**MODIFICATION REQUEST TO CONCEPT
APPROVAL AND STATE SIGNIFICANT
DEVELOPMENT ASSESSMENT REPORT:**

**Concept Approval MOD 9
SSD Application for Block 8**

Central Park (former Carlton United Breweries site)

MP 06_0171 MOD 9 and SSD 6092

Figure 16 Level 10 plan illustrating proposed measures to improve amenity between apartments (Source: Applicant's Additional Information to Council comments)

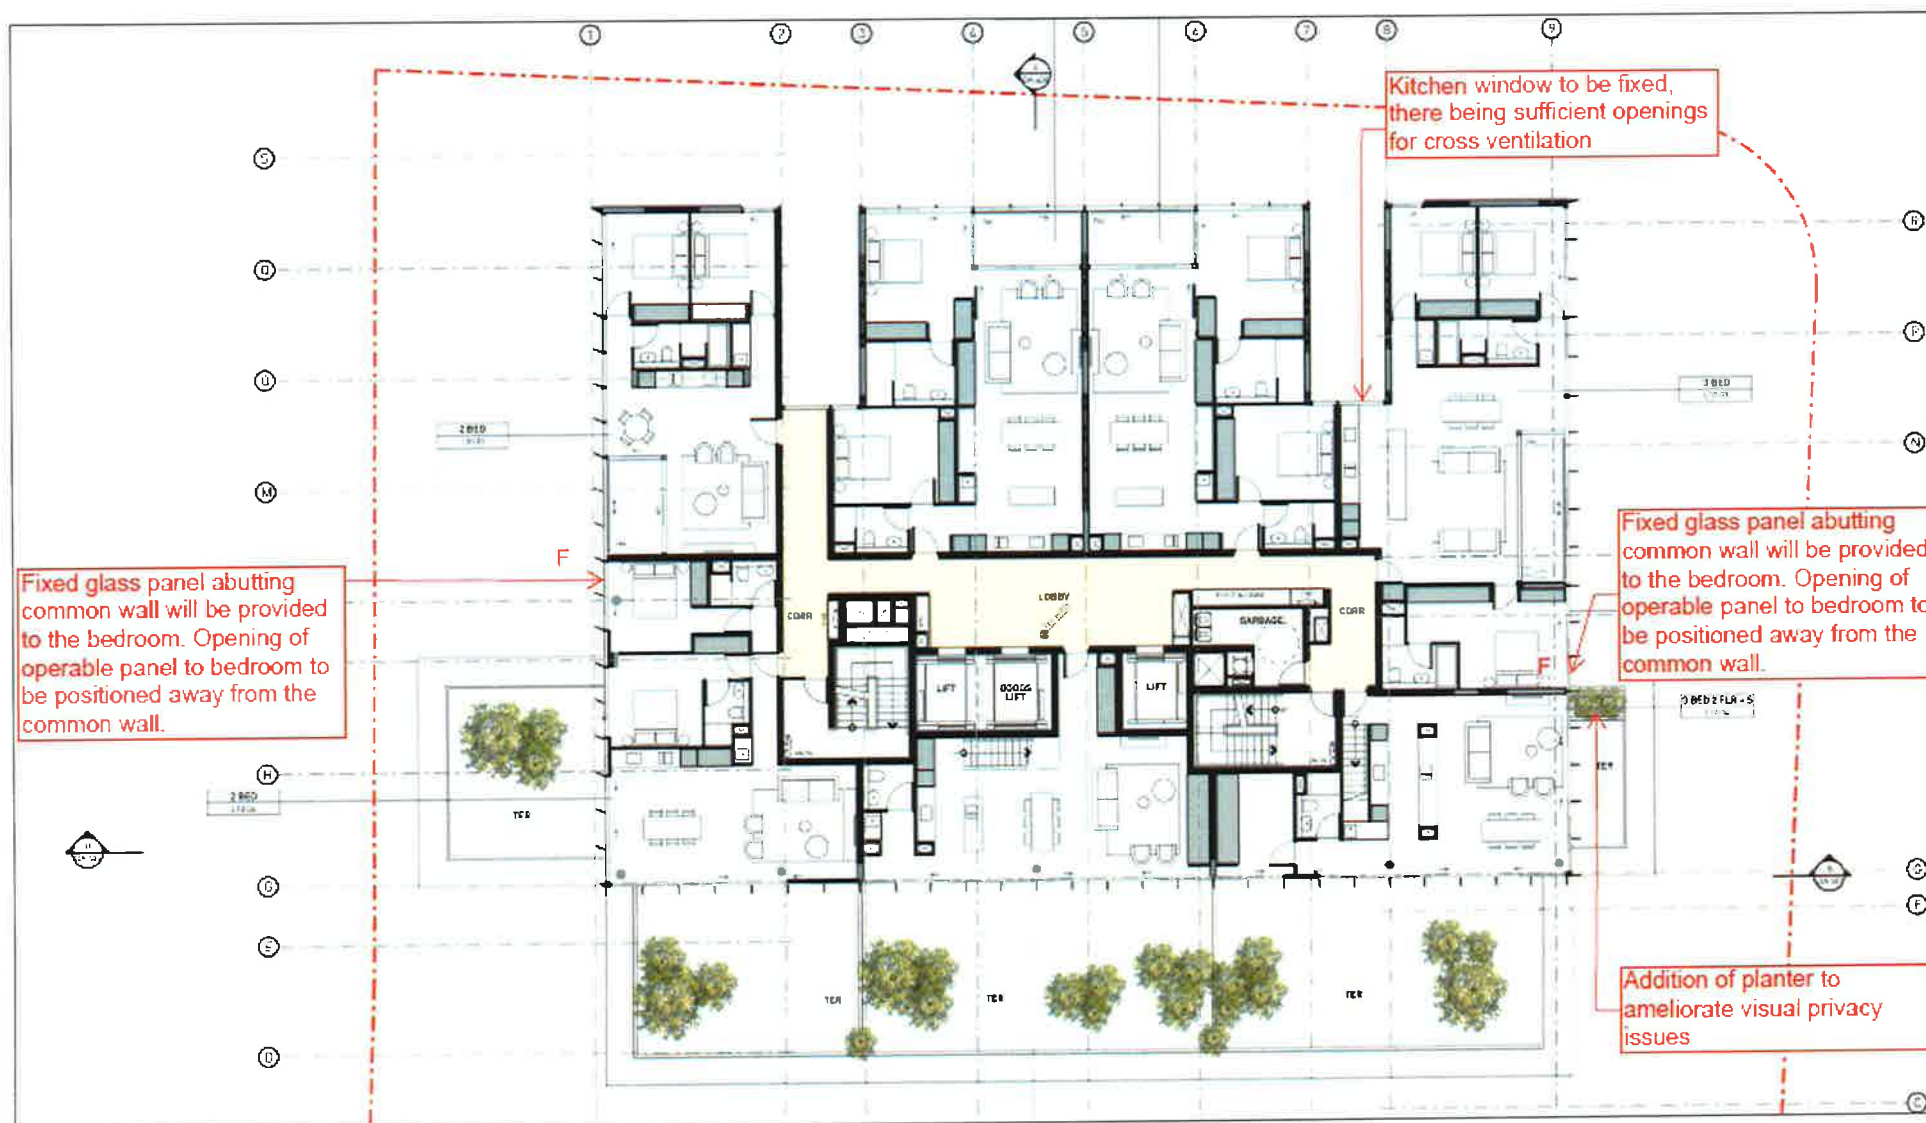
The applicant maintains that in most instances, Block 8 is designed where bedrooms of one apartment are not located adjacent to living areas of another. However, additional measures are proposed to address Council's concerns (**Figure 16**), including:

- kitchen windows being fixed closed (where apartments are already provided with cross ventilation) to prevent transfer of noise to bedrooms in adjoining apartments;
- planter boxes being installed to address potential visual and acoustic privacy concerns; and
- relocating the operable panels to bedrooms away from common walls and balconies.

The Department acknowledges that with the inclusion of the above measures, potential noise transfers between apartments are minimised and residential amenity of apartments are maximised. The measures proposed by the applicant are supported. Condition B3(d) is therefore recommended for amendments to apartments to address privacy concerns.
